memorandum

SUBJECT: HP-2019-COA-01: A request by Andrew Fell for a Certificate of Appropriateness at 2

Buena Vista Court to replace windows, repair exterior walls, replace the porch, add a deck,

and add a door overhang.

Exhibit B: Application (4 | E) (--| w TYP. WALL SECTIONS

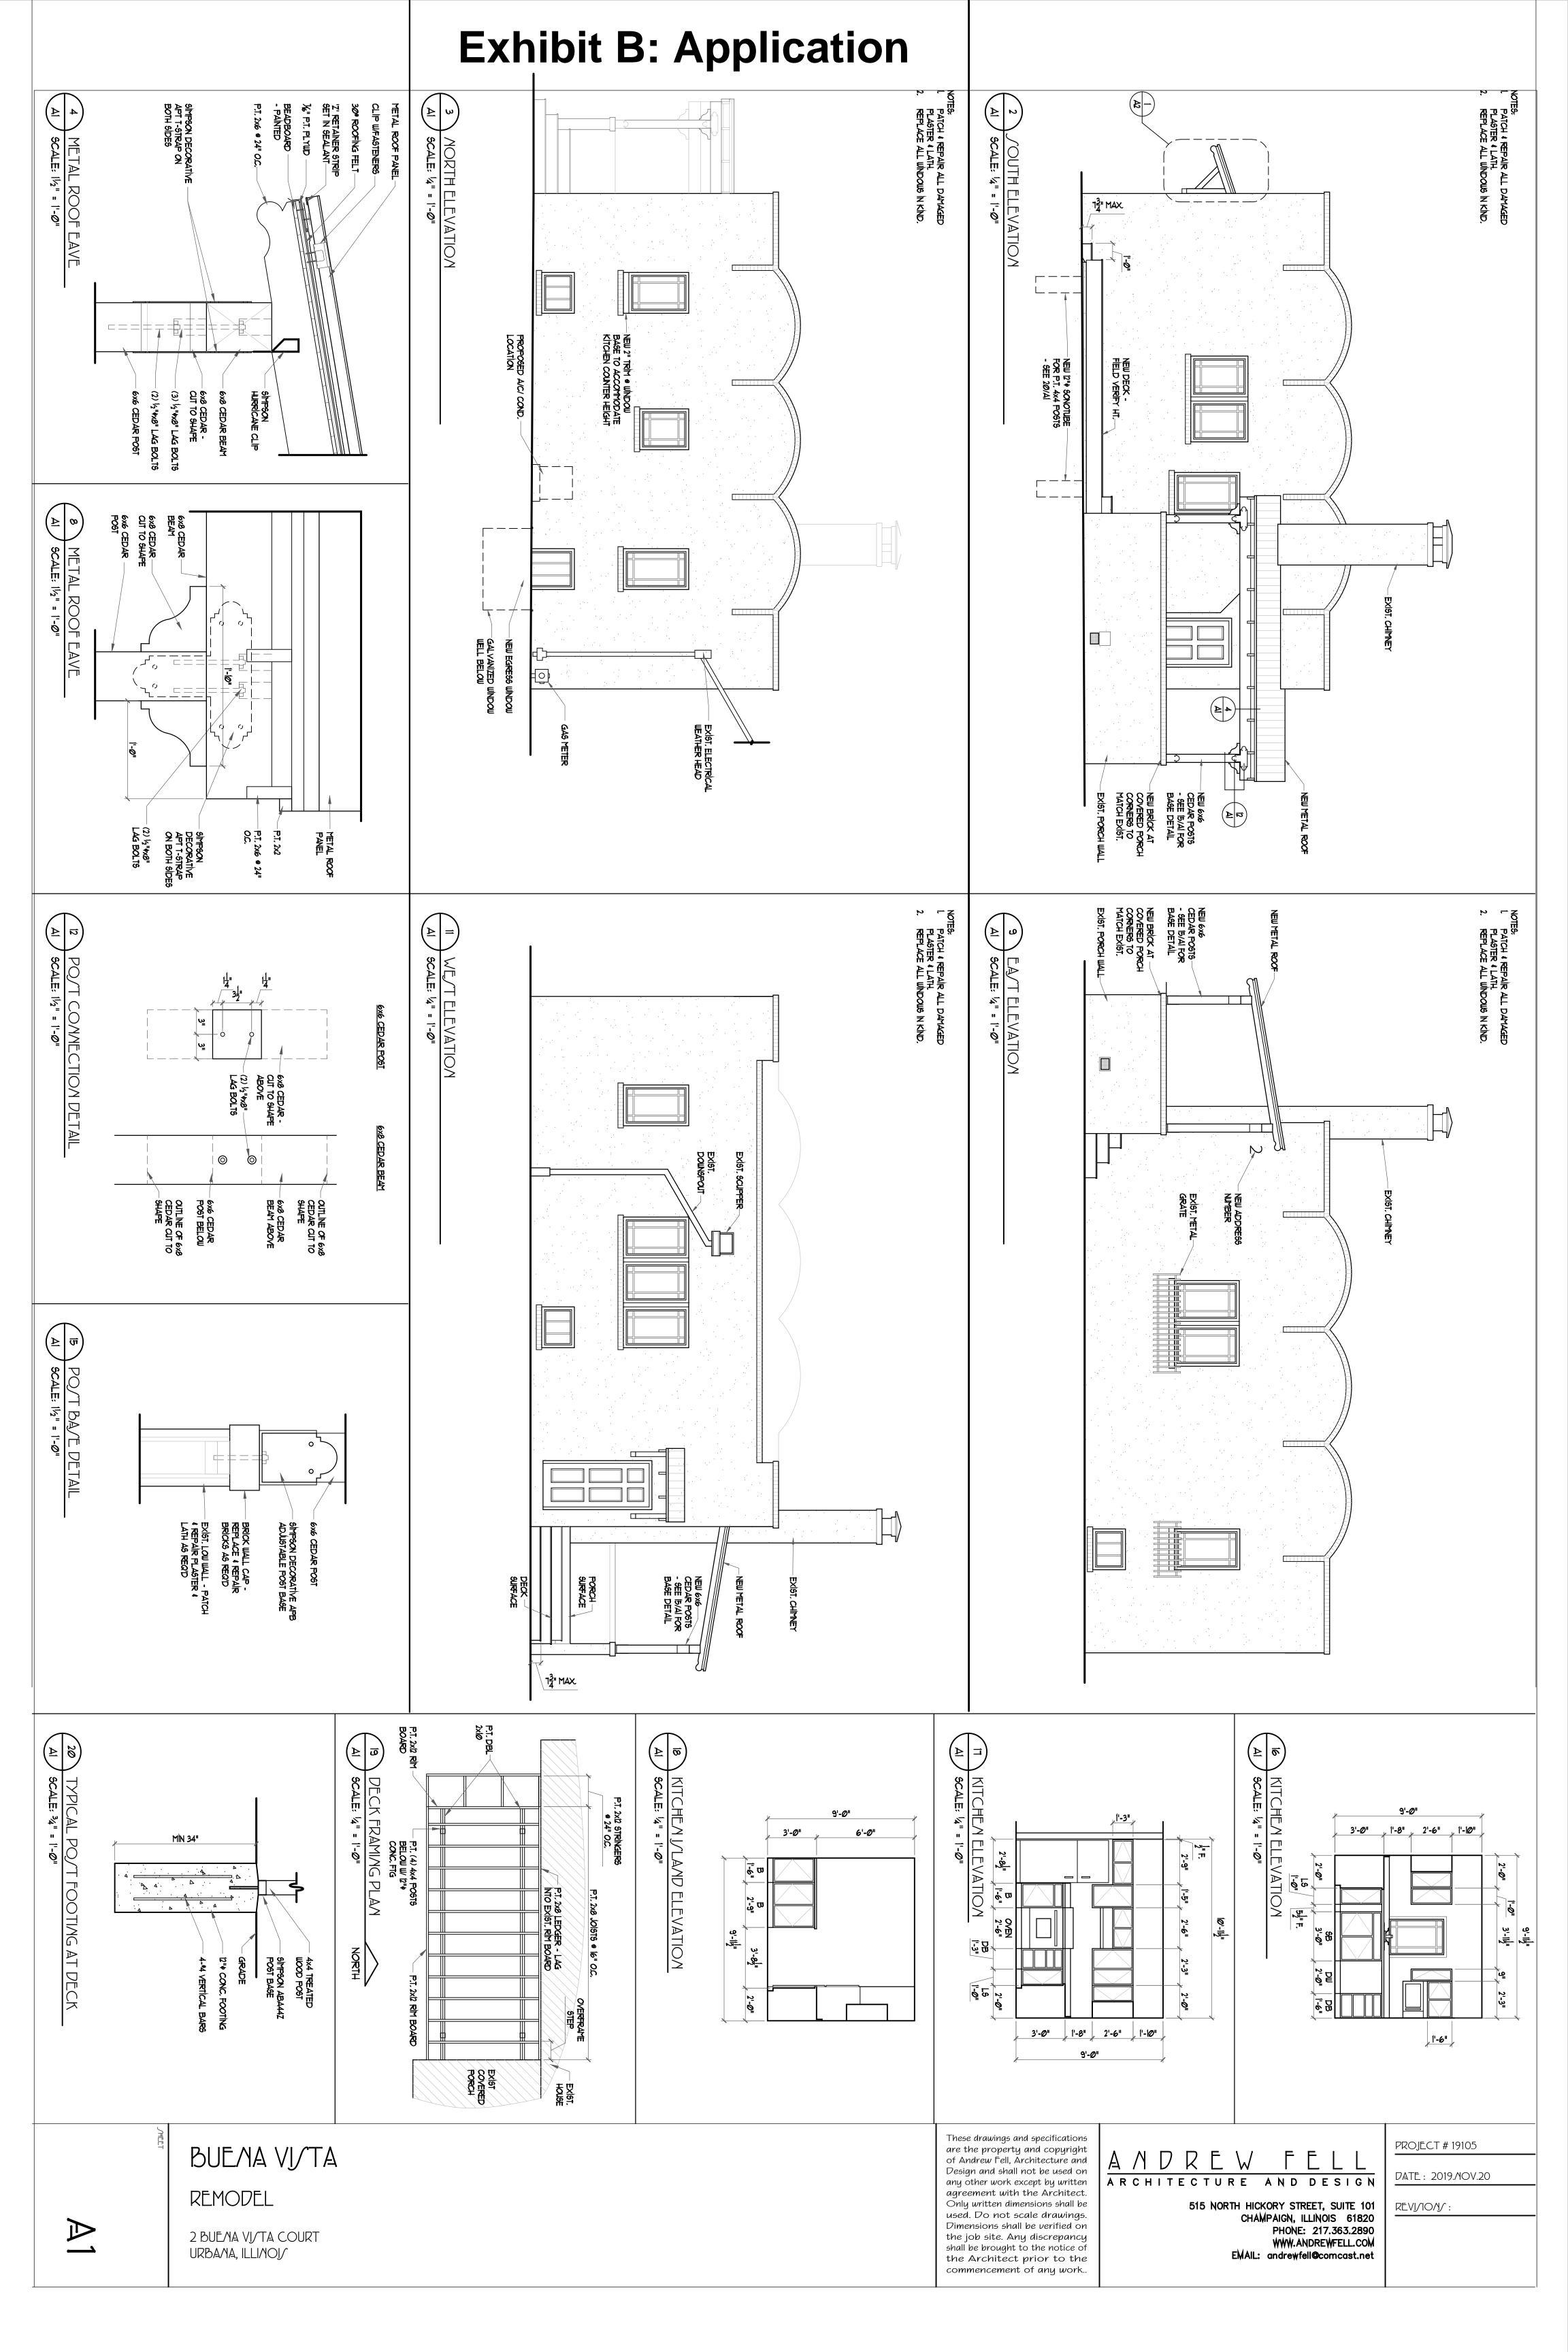
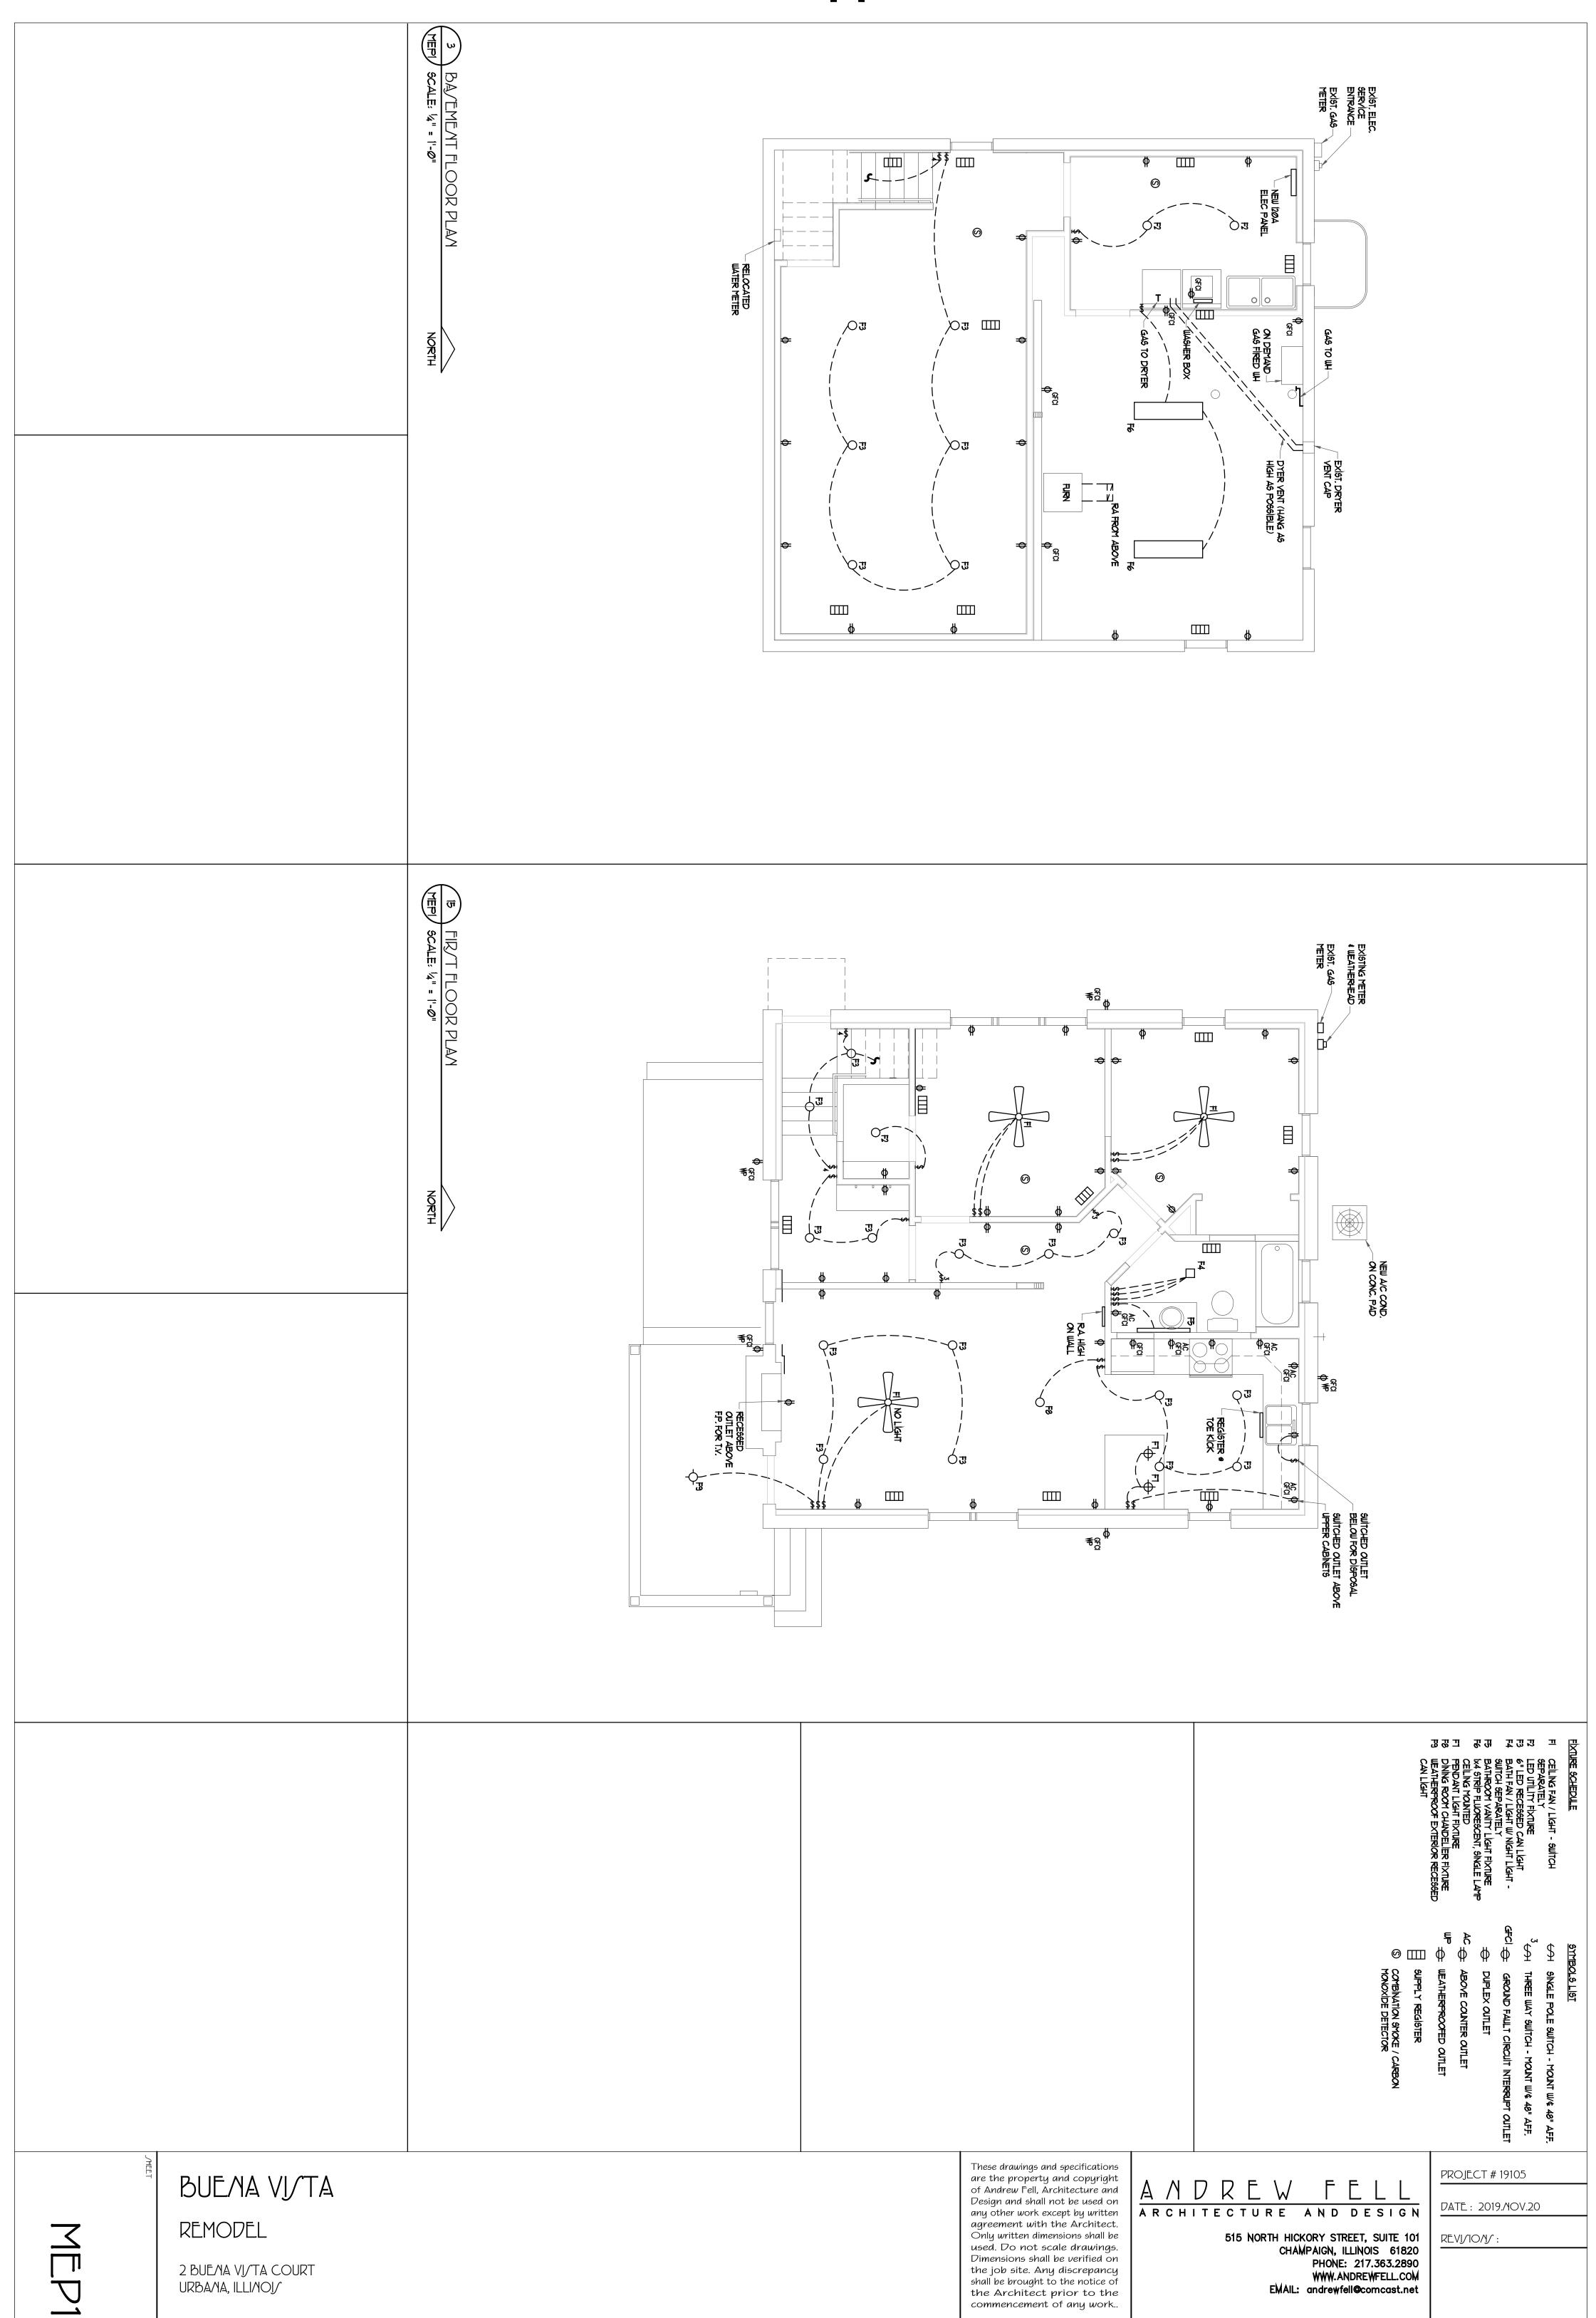
Staff Analysis: The proposed porch repair would replace the stucco-covered columns and beams with cedar beams. While the proposal is consistent with the Spanish Colonial Revival style, the most historically-appropriate treatment would be to replace the deteriorated porch columns in kind with new materials.

Overall, staff believes that this proposal meets most of the requirements for a Certificate of Appropriateness, with the following exceptions: if the original windows are beyond repair, it would be preferable for the replacement windows to be made of wood, rather than vinyl or fiberglass as proposed; and, it would be preferable for the porch columns to be repaired or replaced in kind and stuccoed to match the original character of the building.

- 1. That construction be in general conformance with the attached Site Plan and Elevations, with the following exceptions:
 - a) That the original windows be repaired;
 - b) That the porch columns be repaired or replaced in kind and stuccoed;
- 2. That additional Certificates of Appropriateness be obtained prior to undertaking any minor or major works not contained in the attached Site Plan and Elevations; and,
- 3. That any modifications needed to the Site Plan and Elevations regarding the major works approved in this Certificate of Appropriateness due to conditions discovered during construction activities may be reviewed and approved by the Historic Preservation Commission Chair and the Zoning Administrator, prior to their commencement, and reflected by amending the Certificate of Appropriateness.
